AMENDMENT OF SOLICITATION/MODIFICATION OF CONTRACT				1. Contract Number		Page of Pages	
				DCAM-2011-B-0193		1 1	
2. Amendment/Modification Number		3. Effective Date		4. Requisition/Purchase Request No.		5. Solicitation Caption	
DCAM-2011-B-0193-002		See 16C		711199		Extend DC General Family Shelter Fire Alarm System

14. Description of amendment/modification (Organized by UCF Section headings, including solicitation/contract subject matter where feasible.)							
Solicitation No. DCAM-2011-B-0193 to Extend D.C. General Family Shelter Fire Alarm System is hereby amended as follows:

FIRE ALARM SYSTEM EXTENSION DC GENERAL FAMILY SHELTER - BUILDING 2 1900 MASSACHUSETTS AVENUE, SE WASHINGTON, DC 20003

THIS AMENDMENT RESPONDS TO QUESTIONS RAISED AT THE SITE INSPECTION HELD NOVEMBER 12, 2010, 11:30 AM, AT THE DC GENERAL BUILDING #6. SEE ATTACHED RESPONSES

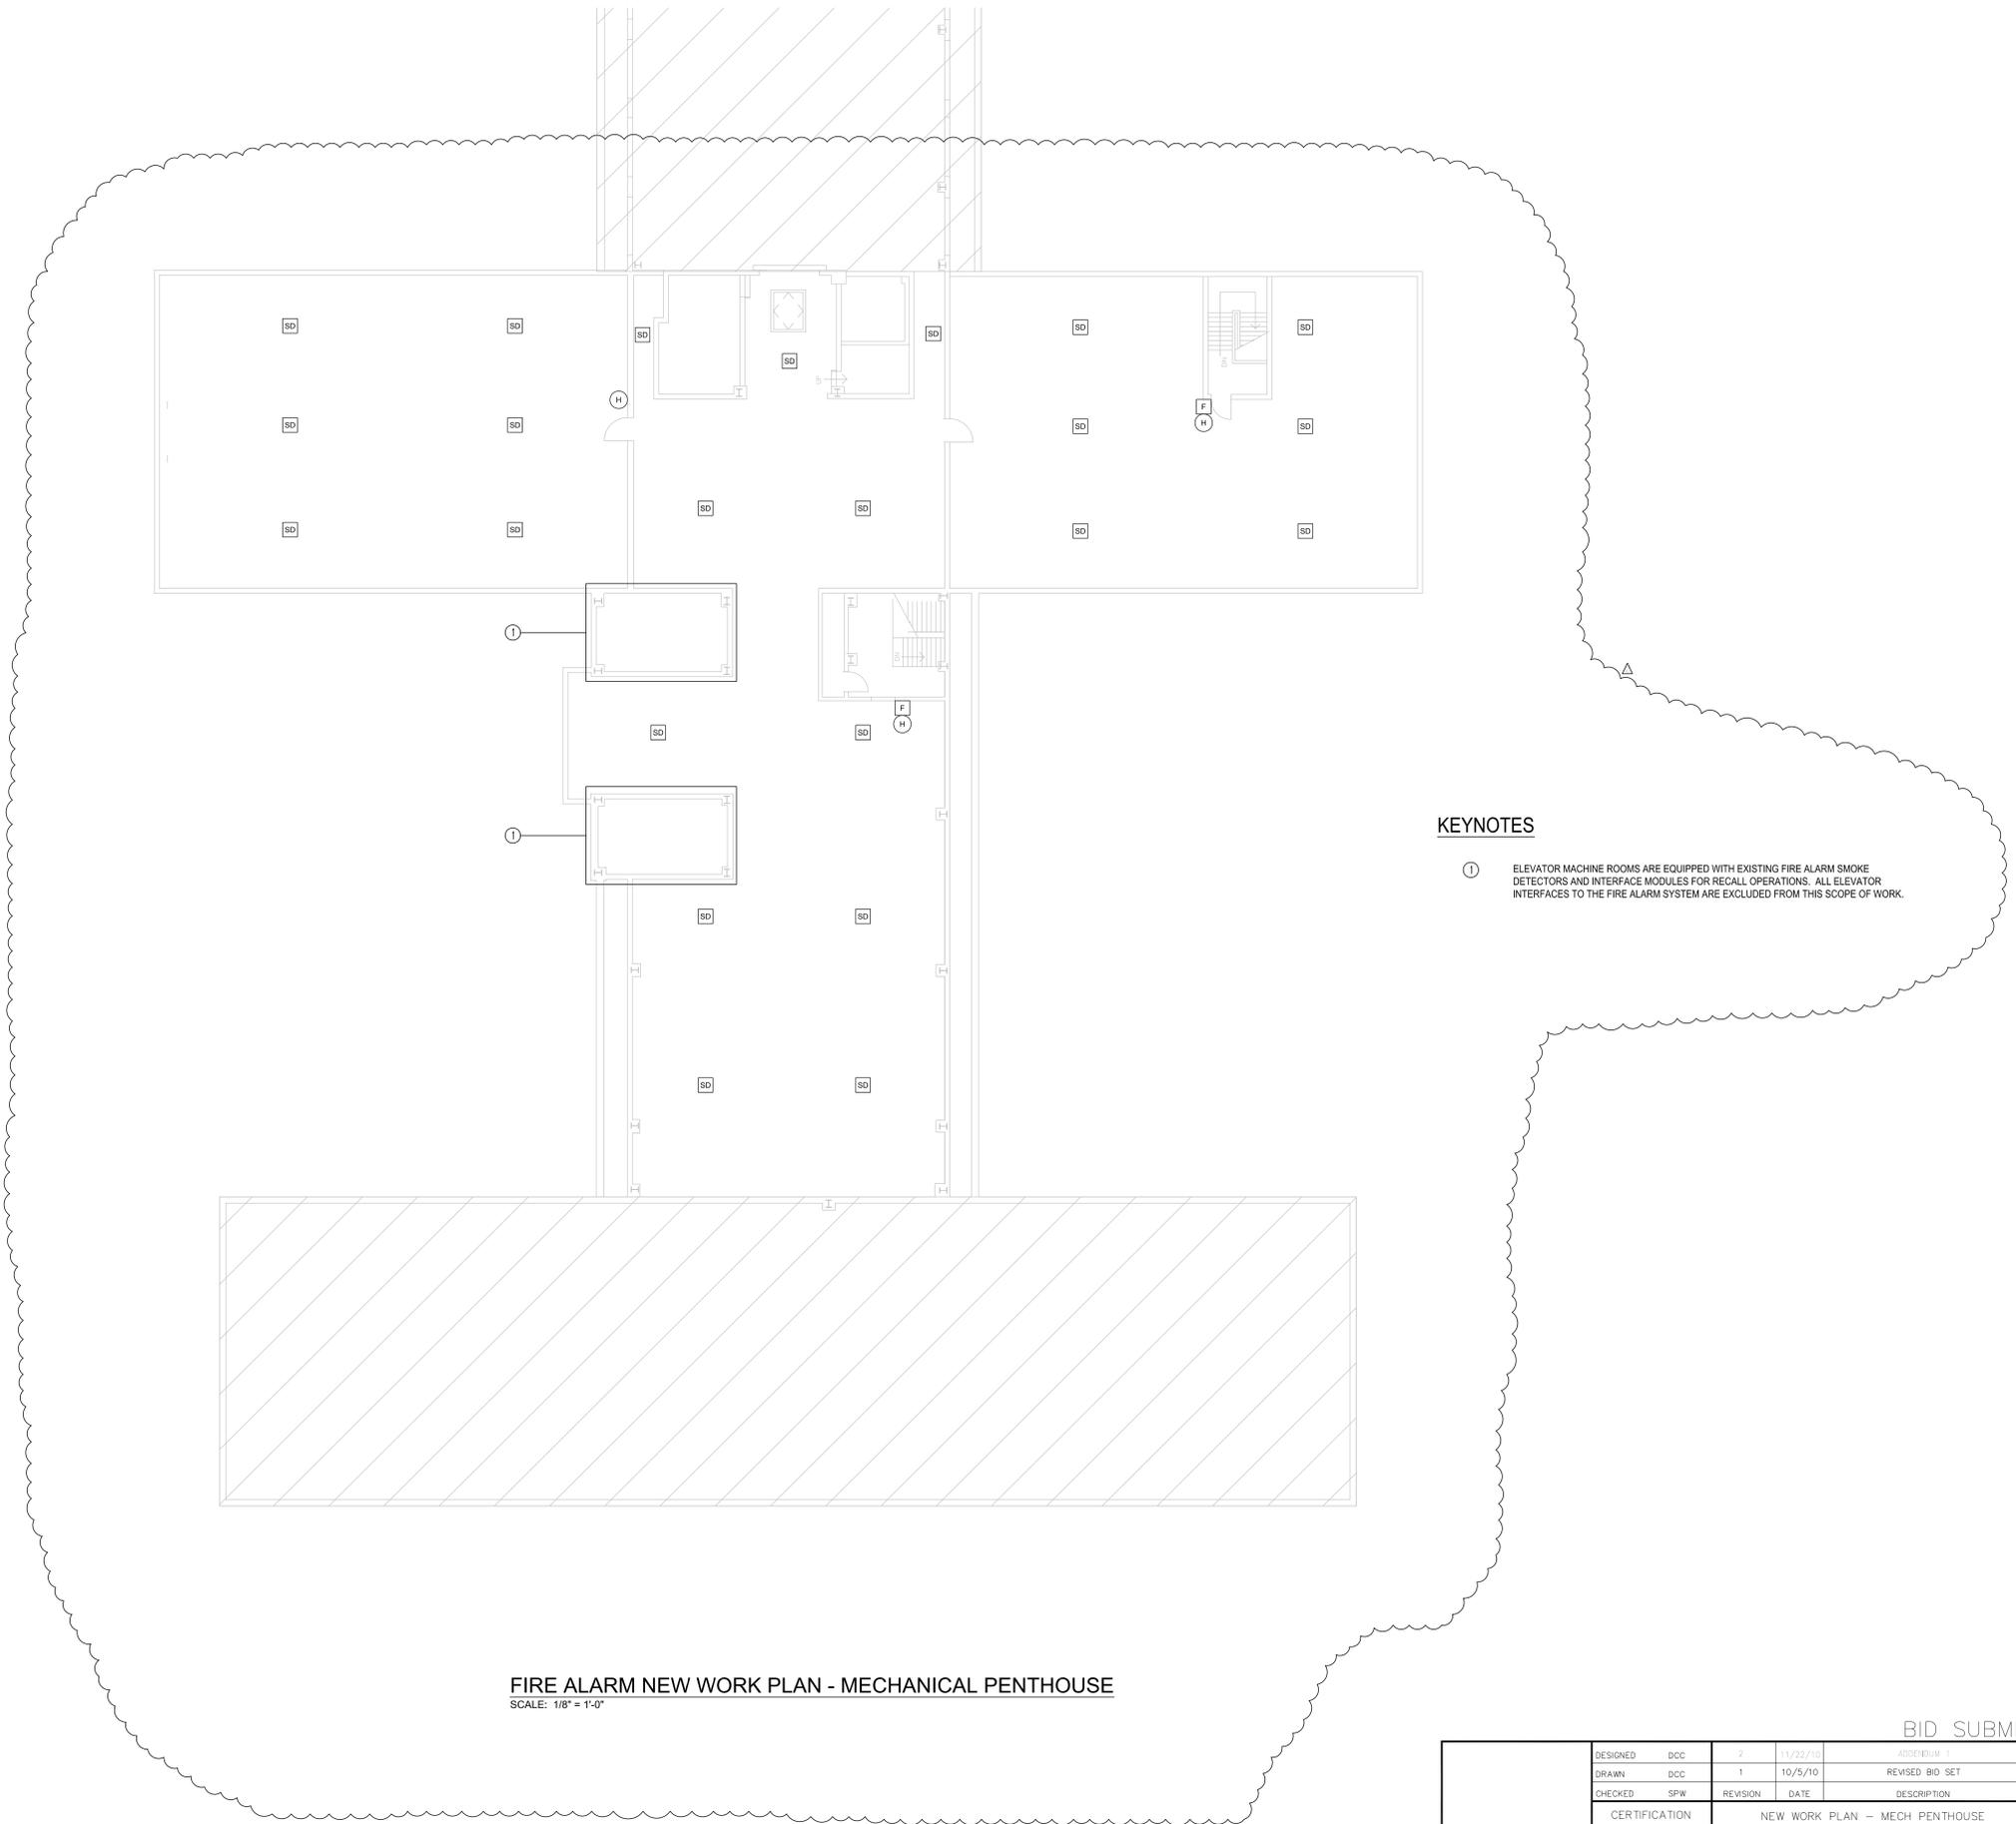
7. **Drawing F-001**

- A. Insert Sheet F-107 (Mechanical Penthouse) to the Drawing Index.
- B. Revise Fire Alarm General Note 7 to include Digital Alarm Communicating Transmitters (DACTs) for the Family Shelter and adjacent Ambulatory Care Center (ACC) Buildings.
